UNITED STATES
NUCLEAR REGULATORY COMMISSION
WASHINGTON, D.C. 20555-0001

MEMORANDUM FOR: James M. Taylor
Executive Director For Operations

FROM: Joram Hopenfeld
Engineering Issues Branch
Division of Safety Issue Resolution
Office of Nuclear Regulatory Research

SUBJECT: DIFFERING PROFESSIONAL OPINION REGARDING VOLTAGE-BASED
INTERIM REPAIR CRITERIA FOR STEAM GENERATOR TUBES

Figure 1
 THREE MILE ISLAND SHUTDOWN "SPIKING" IODINE RELEASES FROM FUEL INTO
 PRIMARY COOLANT ($\mu\text{Ci/g-sec}$) 2/20 - 2/21/76

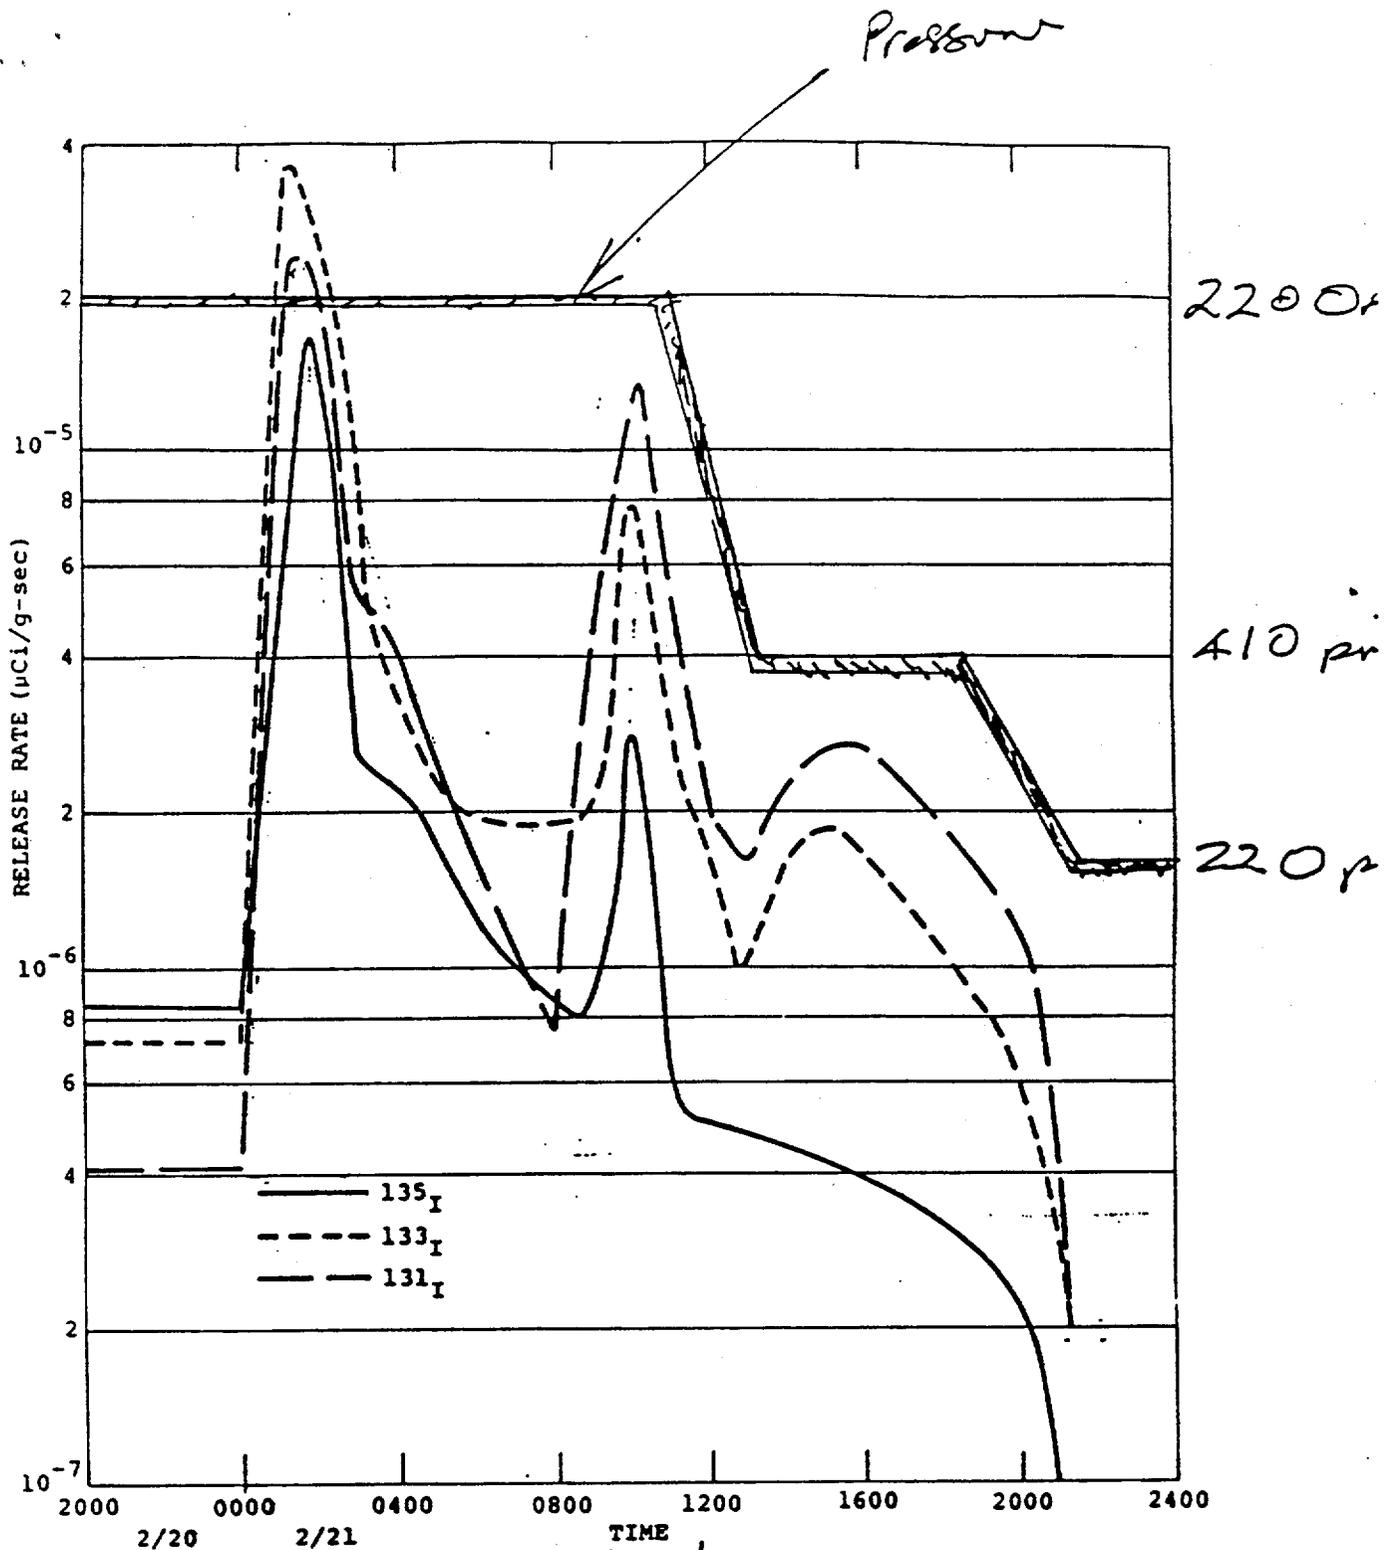
Dose Calculations depend on the initial coolant iodine activity and iodine spiking. Iodine activity limits are controlled by the technical specification (TS) of each plant. Iodine spiking occurs when the power, the temperature or the pressure are perturbed. Increases as high as 10,000X in coolant activity following reactor shutdown have been observed, (4). Present licensing for the design basis SGTR and the design basis MSLB, is based on an empirical iodine spike which corresponds to iodine release rate from the fuel to the coolant which is 500 times the equilibrium release rate. The MSLB/Leakage event can be characterized in terms of a fast reactor coolant pressure drop, (to 800 psi in 200 seconds). It is this pressure transient and the large leakage that distinguishes the MSLB/Leakage from the SGTR and MSLB. The data base for the 500 spike does not include MSLB/Leakage transients, it is expected, however, that these transients will exhibit much higher spikes. Reactor experience (5) indicates that it is the tail end of the pressure transient which most significantly affects spiking, and Figure 1 shows that a pressure change spike releases as much activity into the coolant as a power ramp spike. The present licensing requirements for off-site radiological consequences, as specified in SRP-15.6.3., must be corrected when they are applied to MSLB/Leakage accidents. It should be noted that present dose calculations for the design basis MSLB are based on total leakage of one gpm; therefore, a correction here is not very significant because of the low leakage. When, however, the leakage is large (10 gpm or more) the effect of rapid pressure changes on the spike can no longer be ignored. Not only does the GL ignore this issue, it also uses the TS to incorrectly tune dose predictions.

Figure 2 Release rate ratio (R3/R0) versus the initial iodine concentration

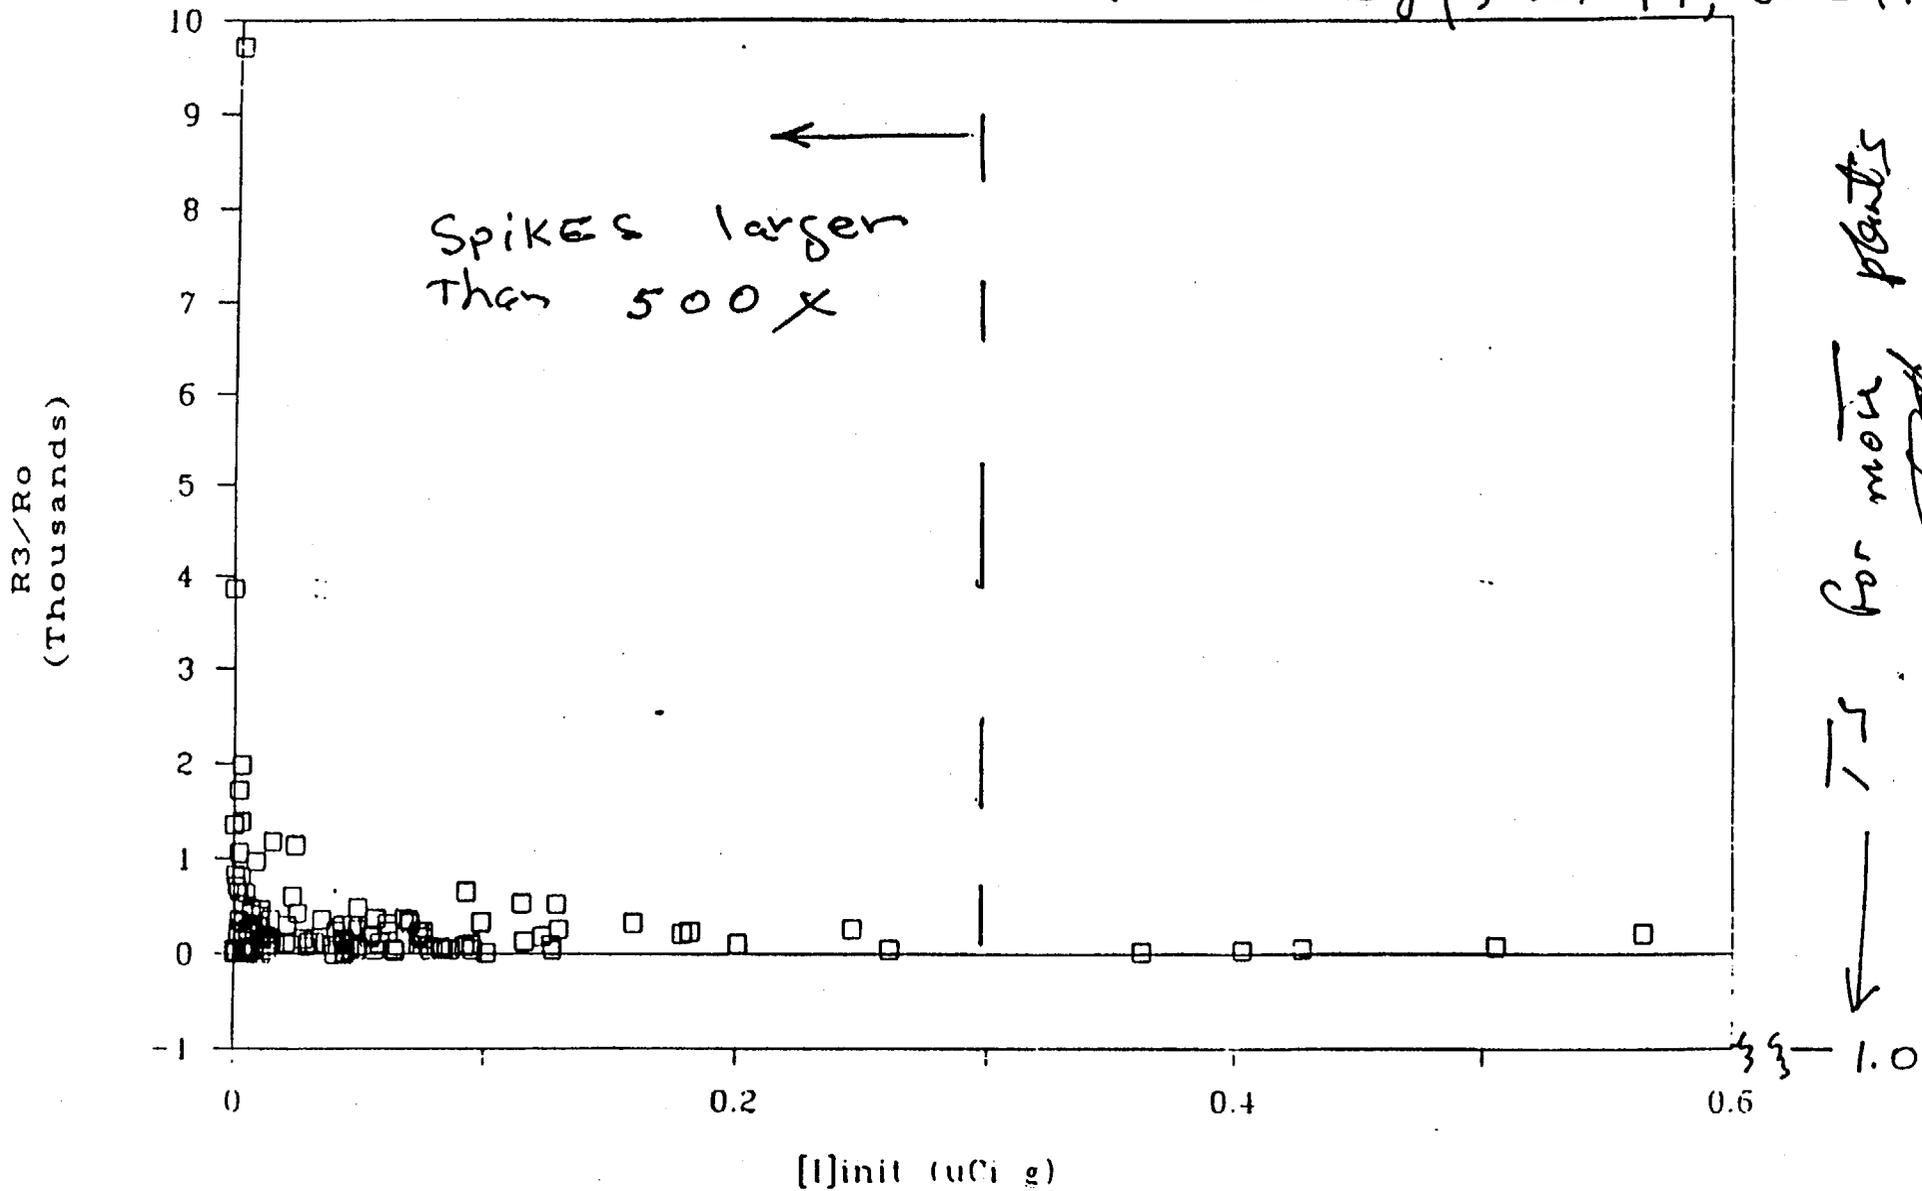
The proposed GL implies that there is a known correlation between initial coolant activity and dose release, and that lowering the technical specification (TS) limits "is an acceptable means for accepting higher

projected leakage rates and still meeting the applicable limits of 10 CFR 100 utilizing licensing basis assumption." Figure 2 indicates that this assumption is not valid, lower coolant activities result in higher spikes.
